North Shoal Creek Neighborhood Association (NSCNA) PO Box 66443 Austin, Texas 78766

Re: Case # C14-2014-0157 (8528-8600 Burnet Road/8647 Rockwood lane, Crump-Gordon

This letter is to reiterate the North Shoal Creek Neighborhood Association's objection to this proposed rezoning. Our previous letter, dated December 5, 2014, was written prior to the issuance of the Zoning Change Review Sheet on December 9, 2014. This letter addresses several points made in the review sheet that we believe to be incorrect, overly general, or misleading. We disagree with staff's recommendation to approve this zoning change request, and we urge City Council members not to approve it.

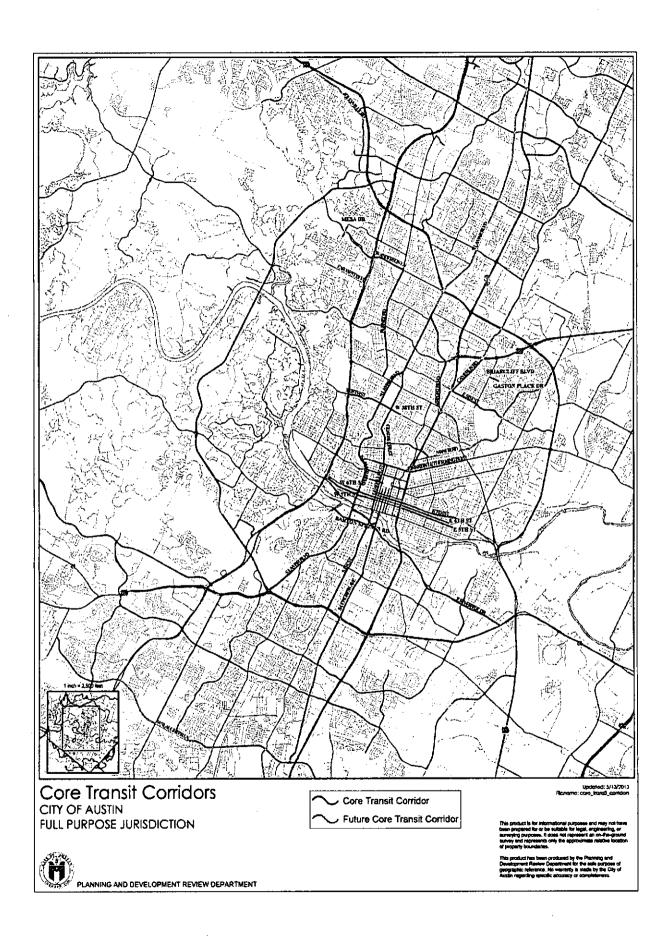
On page 1, the "Department Comments" section recommends approval because "this tract of land fronts onto Burnet Road, an arterial roadway and a designated Core Transit Corridor." Attachment A (a map of Austin's Core Transit Corridors, updated 5/13/2013) shows that Burnet's Core Transit Corridor status ends at Anderson Lane. This section of Burnet is not designated a Core Transit Corridor.
